December 2020  
Fuji Electric Co., Ltd

**MICREX-SX Series**  
**Announcement of Change in**  
**PCI-Bus-Based CPU Board Connector**

We hereby announce that we have changed the loader connector form of the PCI-bus-based SPH300 CPU board (Type: NP3PS-SX1PCS32/NP3PS-SX1PCS74) in the MICREX-SX Series SPH.

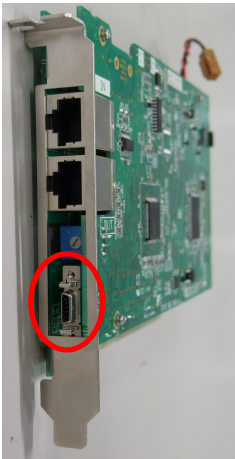
Target model	Before change	After change
PCI-bus-based SPH300 CPU board  NP3PS-SX1PCS32 NP3PS-SX1PCS74	Loader connector: Small sized connector  	Loader connector: RJ45 type

Reason for change: The current connector was discontinued.

- (1) The change have been made from the production in November 2020.
- (2) According to this change, the hardware version was changed from “26” to “27.”
- (3) There are no changes in the price and the other specifications (except the loader connector).
- (4) According to this change, the applicable loader connecting cable type was also changed.  
Applicable type before change: NP4H-CB2 + NW0H-CNV  
Applicable type after change: NW0H-CA3 + NP4H-CVU
